Planning Board Staff Report

RE: Site Development Plan Amendment (SDPA) 25-000130, 415 Lily Ct.
South Water Treatment Plant – Public Works office, shop/warehouse space building, and open storage structure

PROPOSED SITE PLAN

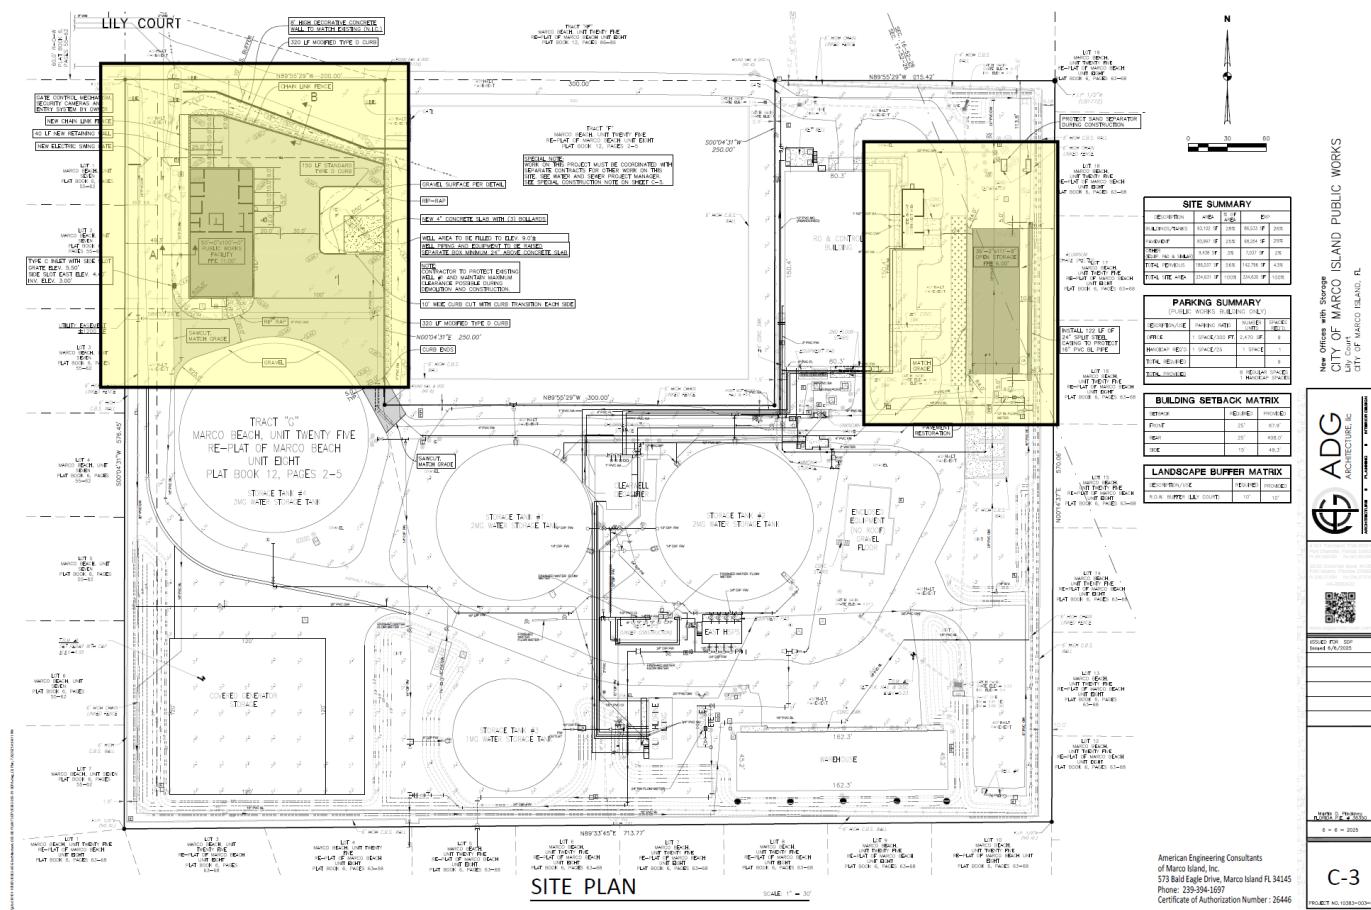
Overall, Staff does not have real concerns with this request. The setbacks, height, parking, use, etc., are met. A few items are missing on the site plan, such as one parking space and the minimum landscape size requirements, which have been added as a condition of approval.

1. Landscape plant material must meet code requirements. Deciduous trees must have a minimum of 3-inch caliper.
2. Add one parking space for a total of 9. Only 8 are shown.
